16089B-01

<u>SERVICE NOTE</u>

16089B Medium Kelvin Clip Lead

This service note provides the updated part numbers and figures for both RoHS and non-RoHS 16089B Medium Kelvin Clip Lead

Figure 1-1

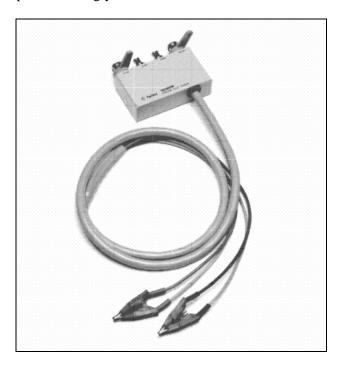
Shown are the supported parts and their respective RoHS compliant replacement support part. RoHS conversion involves with design and dimension change which result in the RoHS support part backward incompatible with non-RoHS 16089B. Special handling is needed while using the RoHS replacement part on non-RoHS 16089B. The original support part number is replaced by the respective "RoHS Compliant Replacement Part". Once the original support part is depleted, please proceed to obtain the RoHS compliant support part. Please refer to table 1-1 and figure 1-1 for the respective replacement part accordingly.

NOTE: For RoHS Compliant Upper Level Assembly Replacement Part, if multiple parts are replaced by a common higher assembly part, only order ONE part of the higher level common assembly.

<*1> 16089-60602 is removed from support parts due to increasing costs. Purchase 16089B Medium Kelvin Clip Lead as the replacement.
